**SANDOVAL COUNTY
REGIONAL ANIMAL RESOURCE CENTER
VISTA SANDIA COURT
Bernalillo, New Mexico 87004**

**ADDENDUM NO. 01
FY26 - SCPW - 07**

November 17, 2025

C-201

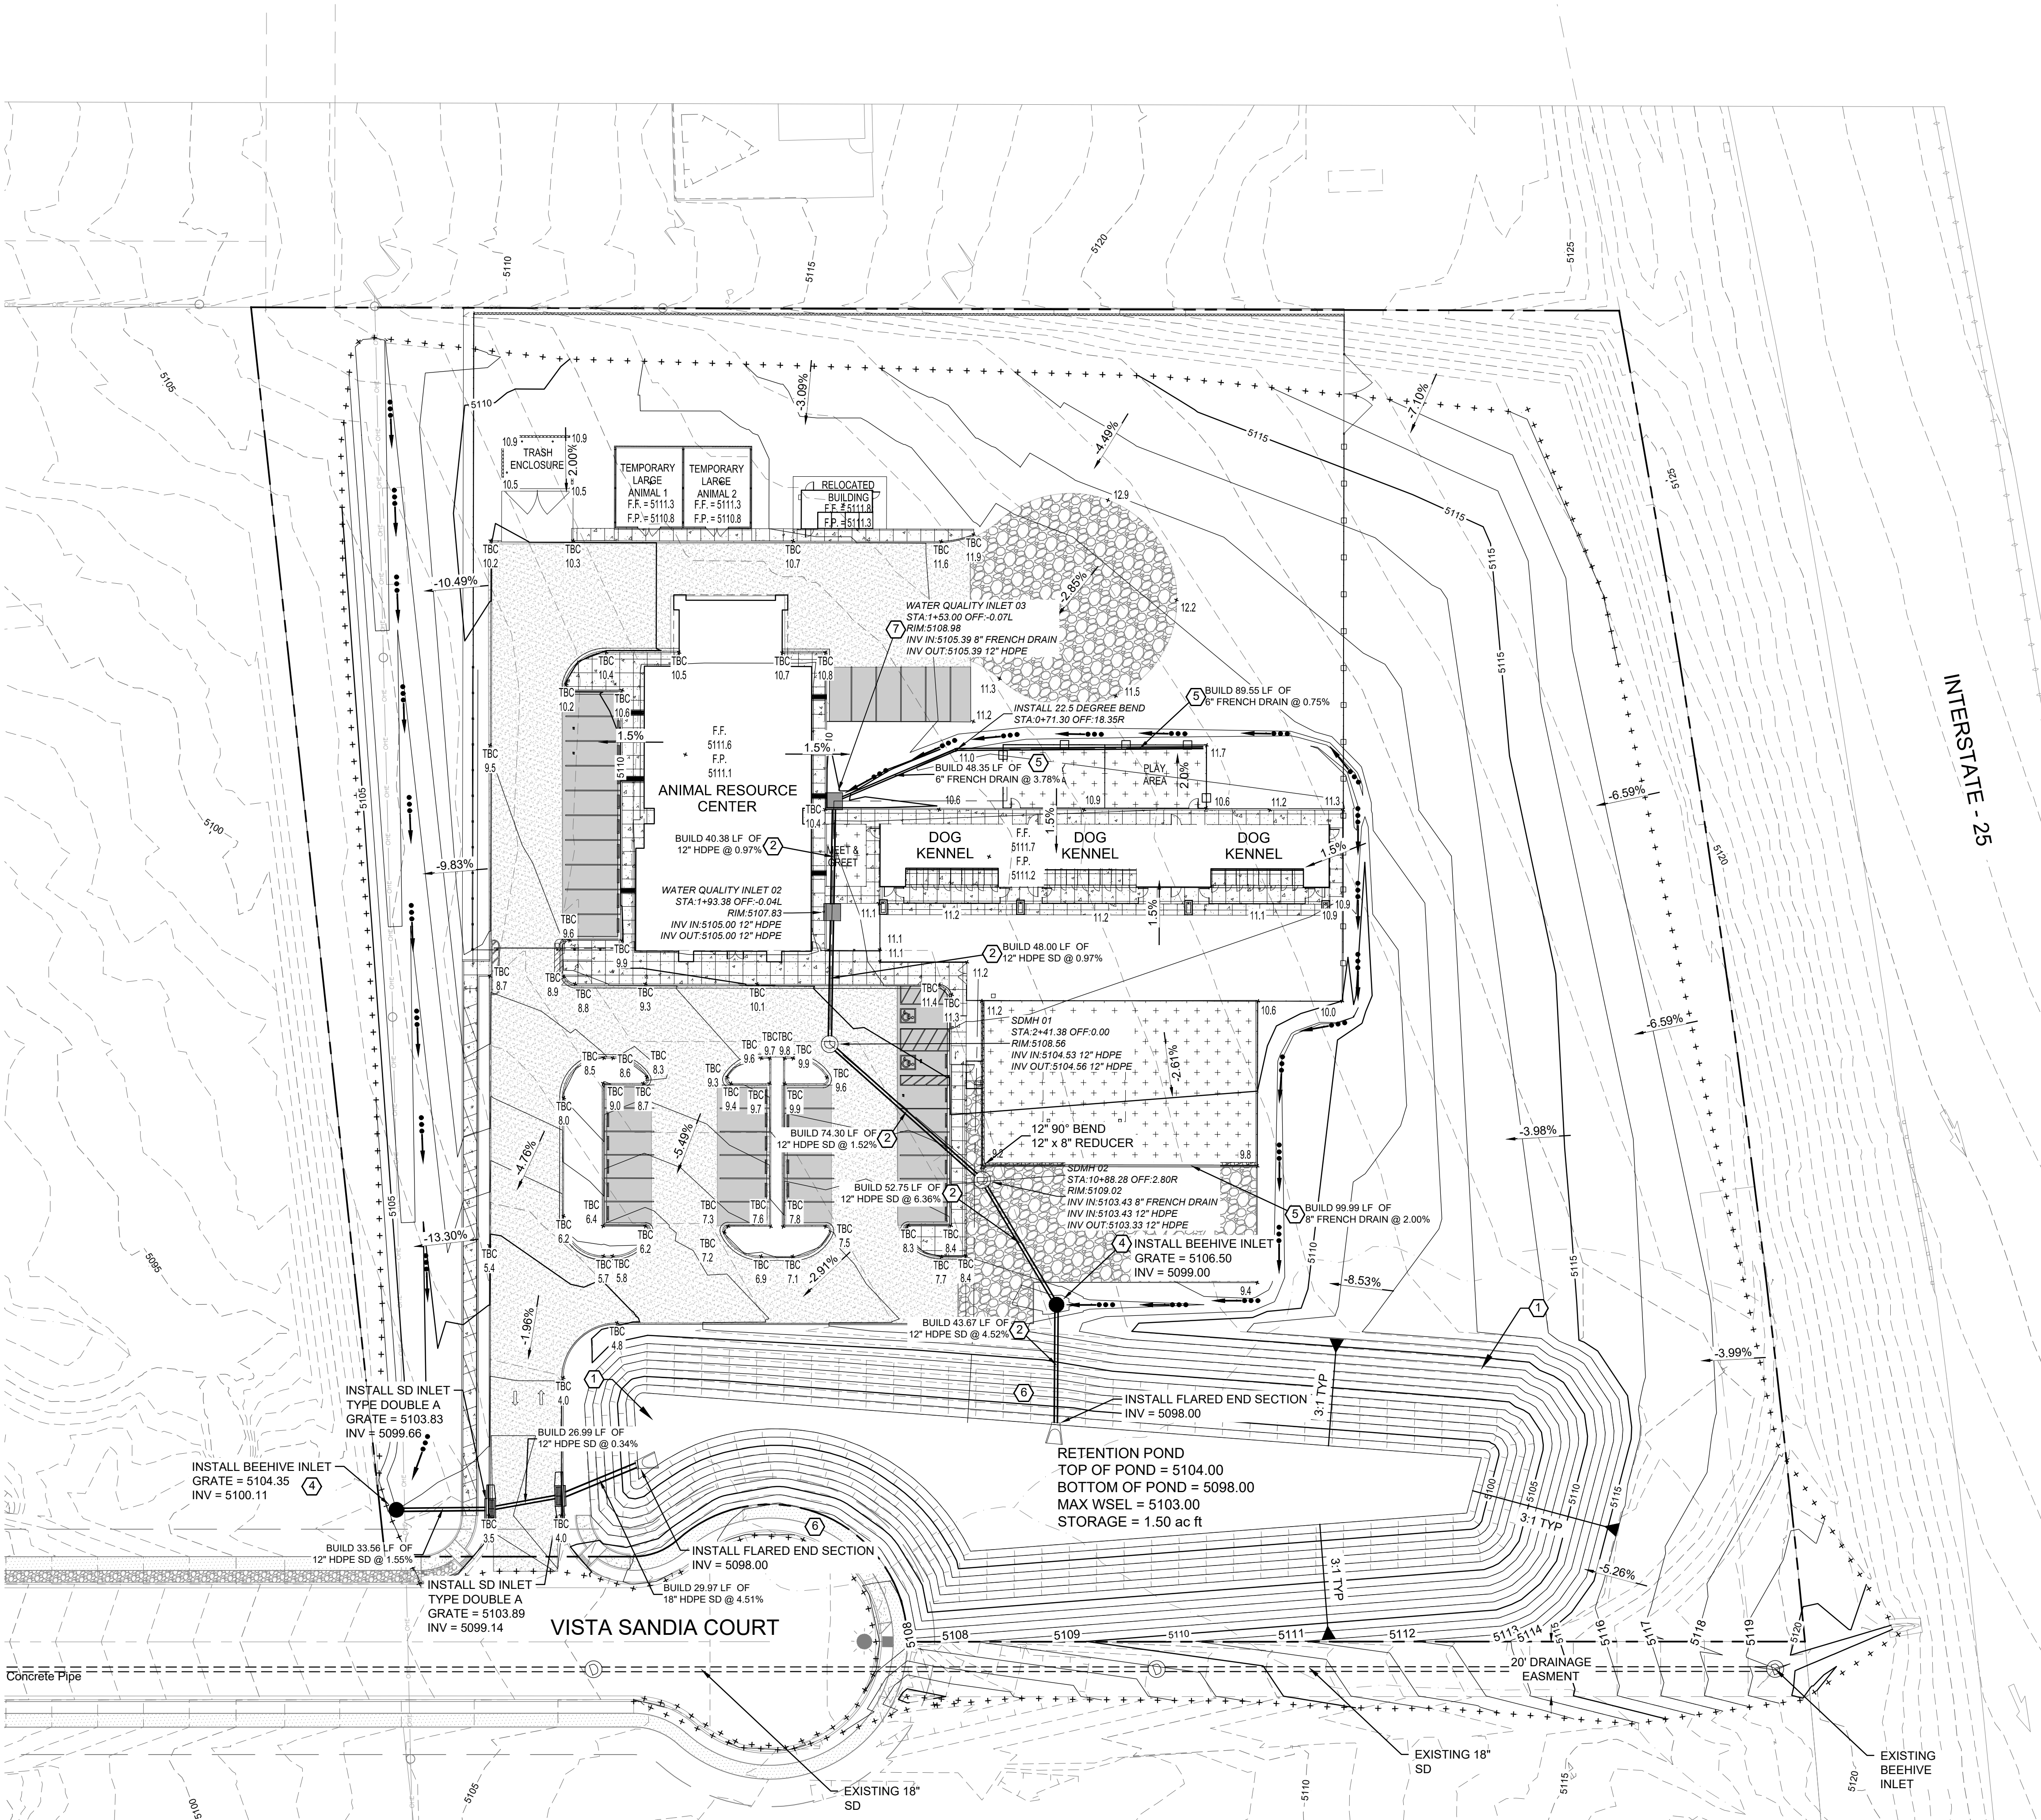
26. Sheet A603 shows door type L, no type L is on the schedule. Is there any type L doors in this project?
Response: No. Type L is not used.
27. Sheet C201 please verify the size and locations for all the french drains.

38. Sheet C201 keynote 2 calls for 12" HDPE Storm Drain, the grading plan uses this same keynote for 3 different items: 12" French drain, 12" HDPE storm drain, and 12" RCP Storm Drain, please clarify.

45. Please confirm what work is already done on site to sheet C201.

Response: Missing sizes have been identified on Sheet C201. Civil sheet will be reissued via addendum.
28. Sheet A201 detail A1 West Elevation shows type C window right after grid line B, which doesn't match window typ C, seem this should be window type B. Window is also calling for type B between grid lines D & F which should be window typ C. Floor plan is showing the whole West to have all C windows 6 total, not B's. Please clarify.

Response: RCP will not be used on this project. Civil sheet will be reissued via addendum.

Response: Civil sheet will be reissued via addendum.

C-301

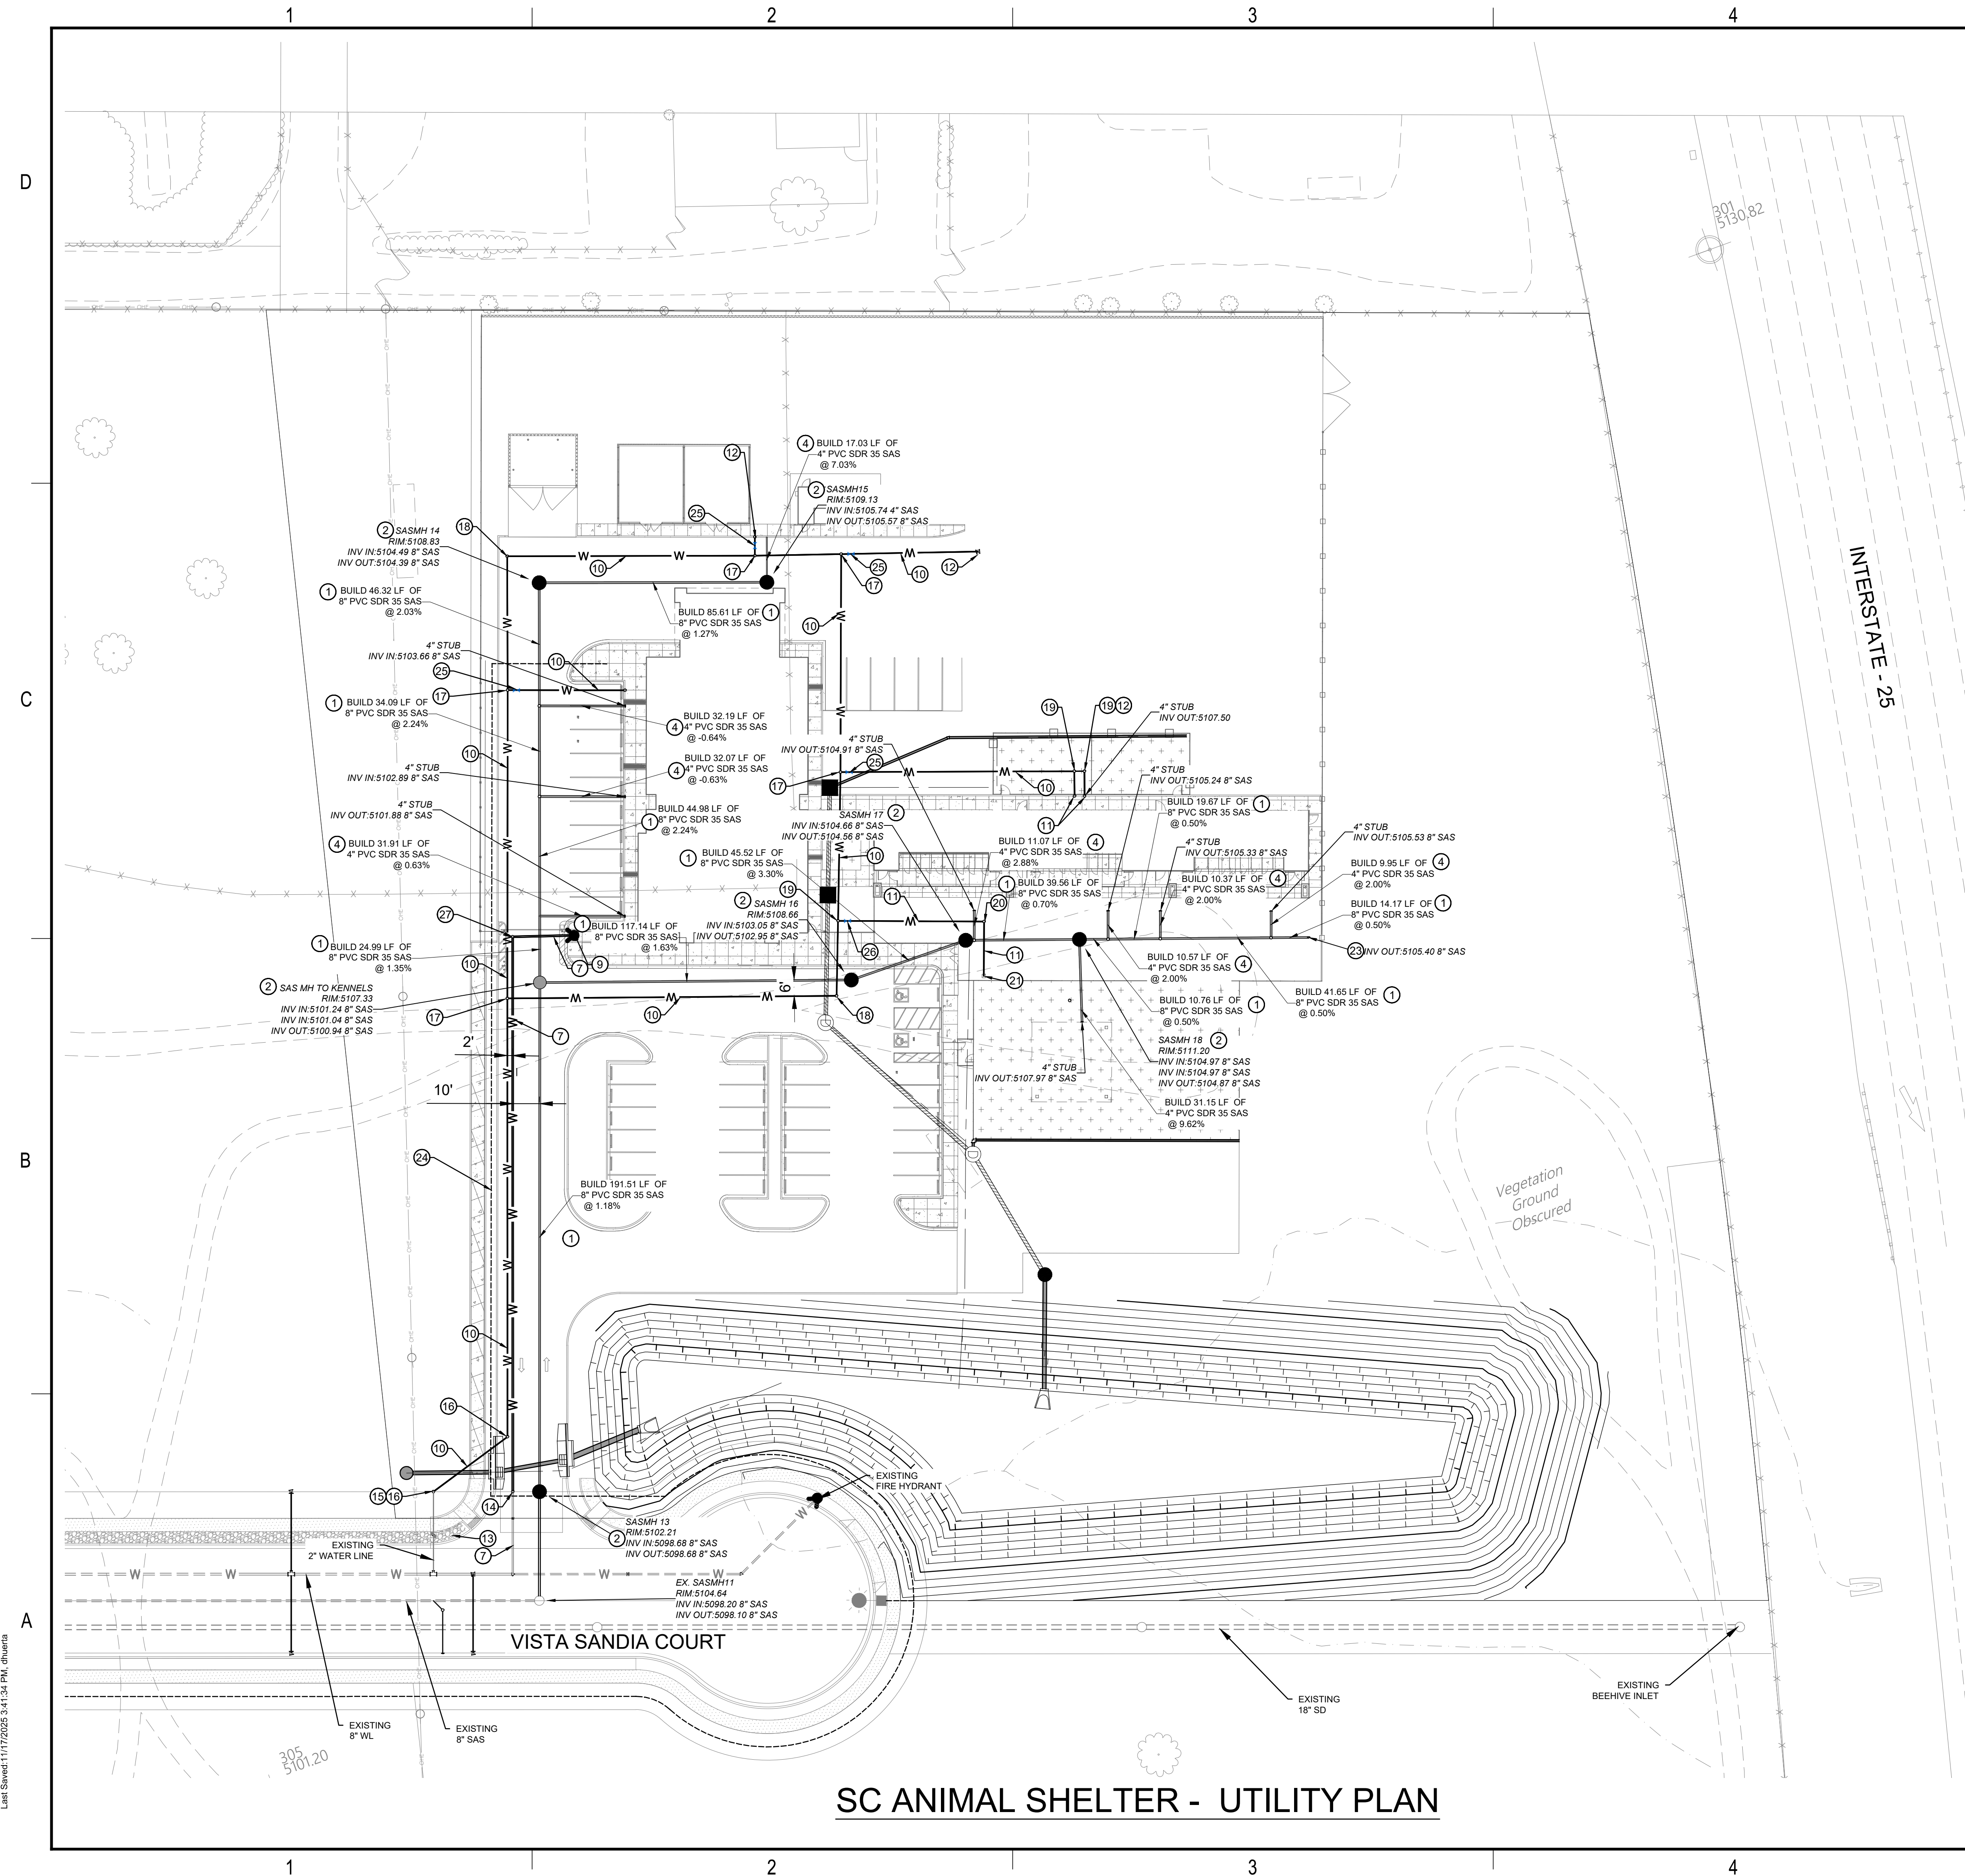
39. Sheet C301 in the Vista Sandia Court cul-de-sac, should the keynote 3 for the manhole be keynote 2 because keynote 3 states "not used"

40. Sheet C301 should the arrow for this manhole be pointing to the new manhole in the access drive to the new facility and not the existing manhole in Vista Sandia Court?

41. Sheet C301 the sanitary sewer line running North from Manhole 15 is labeled 4" and keynote 1, Keynote 1 calls for 8". Please clarify. Is the line just to be capped?

42. Sheet C301 the sanitary sewer line running to Southwest corner of the building is labeled as 8" and Keynote . Which keynote 4 calls for 4". Please clarify.

43. Please clarify the underground electrical service scope. Sheet C301 keynote 24 doesn't correspond with ES101.

46. Please confirm on sheet C301 that there are stub-outs for domestic water and fire line north of the asphalt paving of Vista Sandia Court and that there will be no cut/patch of this new road.

Response: Civil sheet will be reissued via addendum.

Response: There is no new manhole in the access drive, the arrow is pointing to an existing manhole in Vista Sandia Court. Civil sheet will be reissued via addendum.

Response: Civil sheet will be reissued via addendum.

Response: Civil sheet will be reissued via addendum.

Response: Civil sheet will be reissued via addendum.

Response: Civil sheet will be reissued via addendum.

LIGHTING PLAN

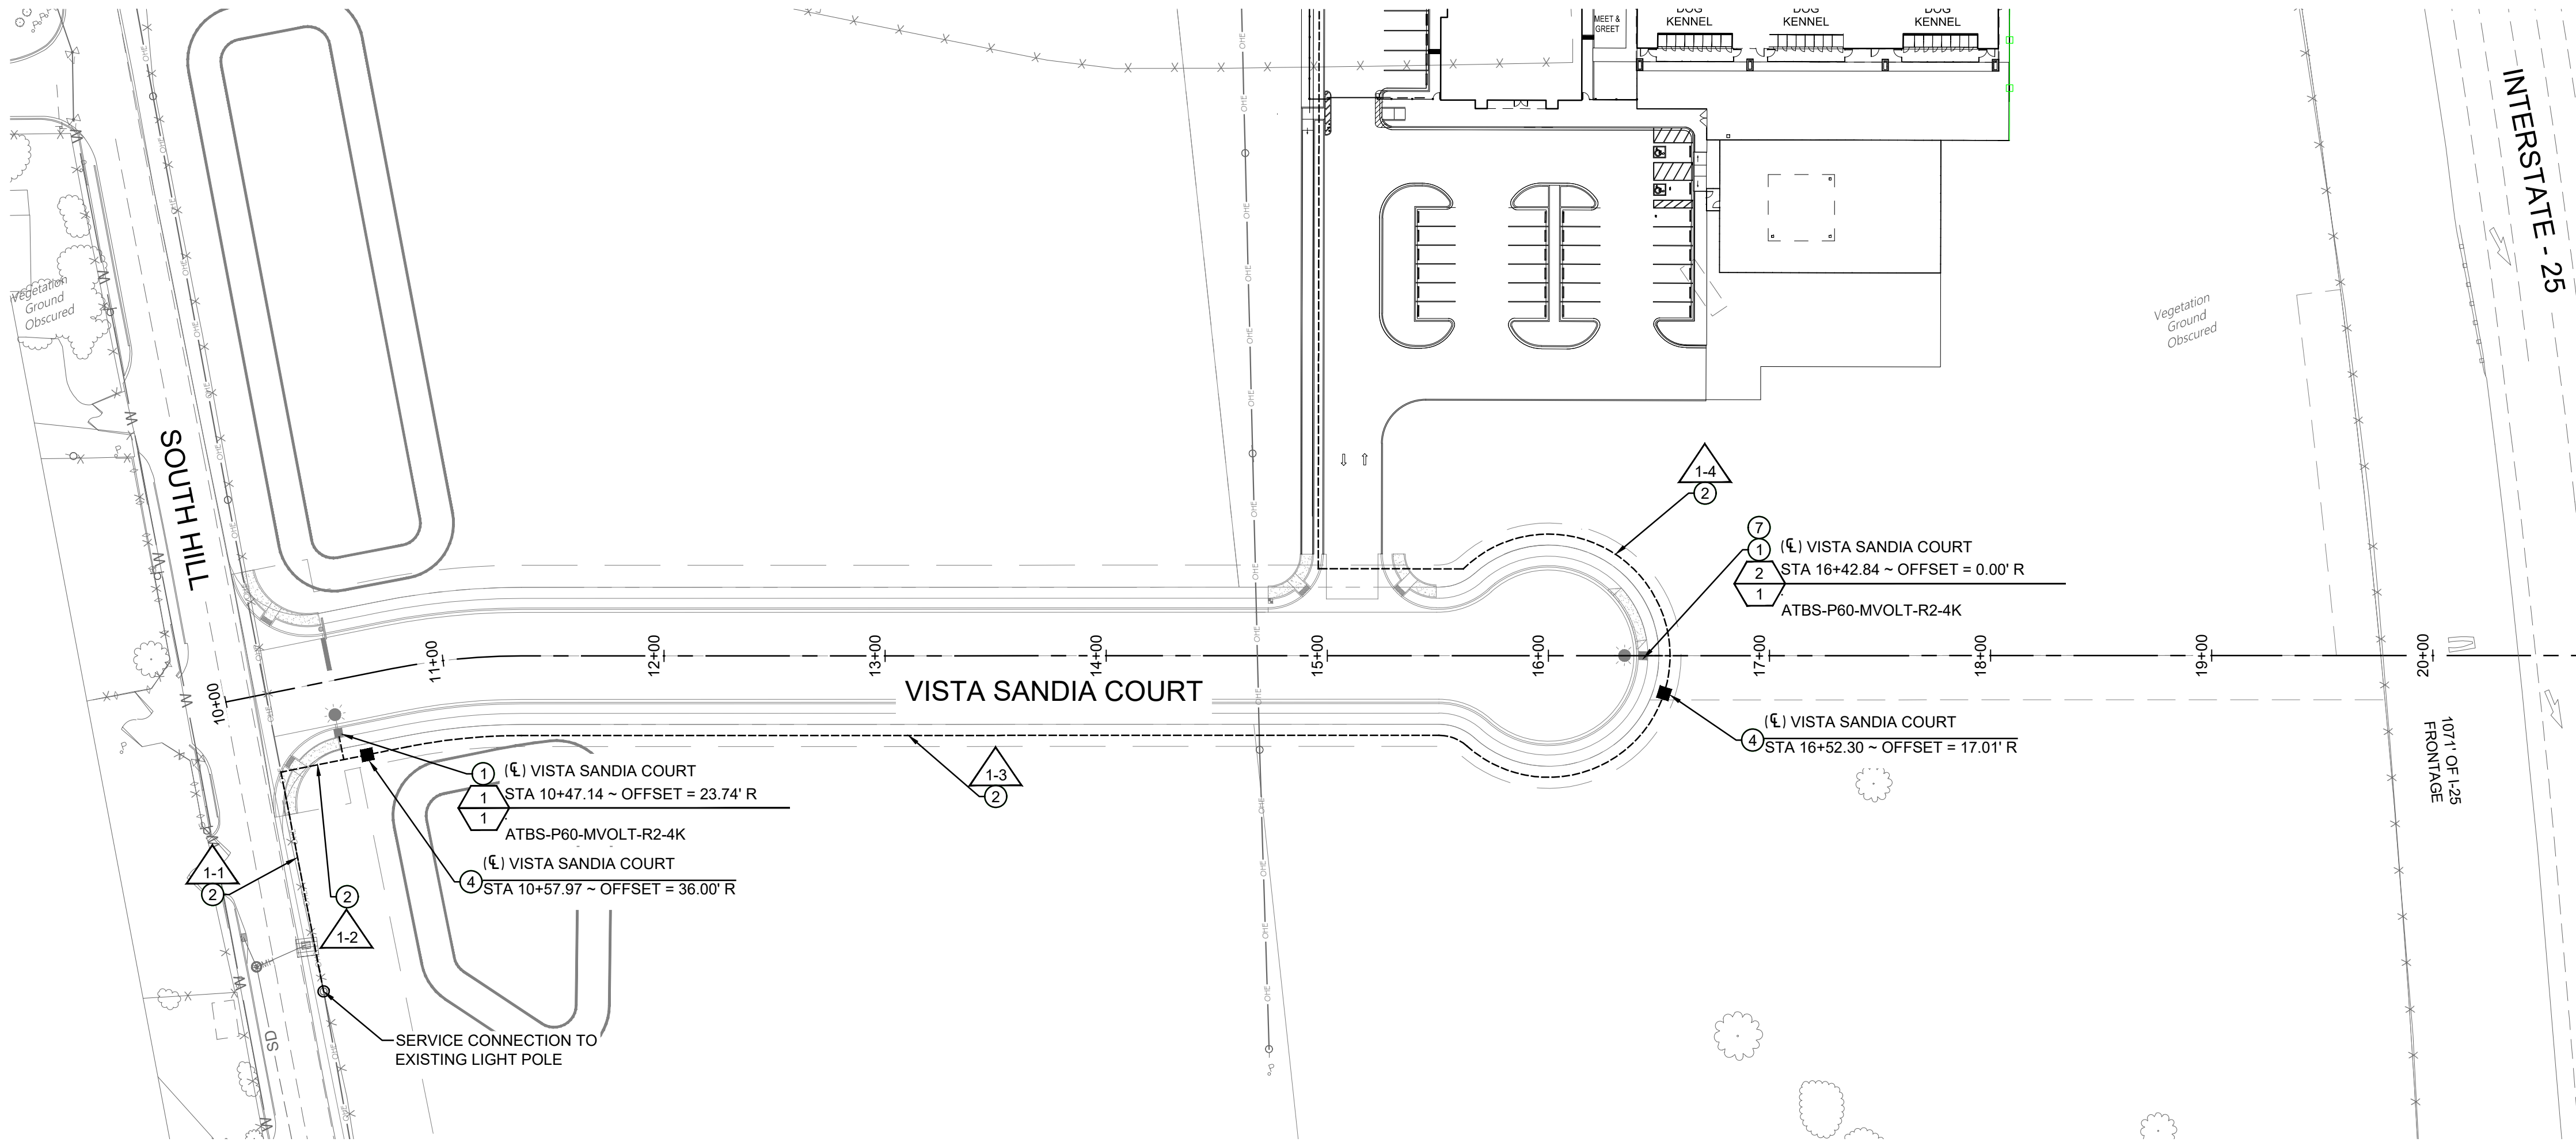
44. Please confirm if roadway lighting, Sheet C401 keynote 01 is to be included in this scope.

Response: Civil sheet will be reissued via addendum.
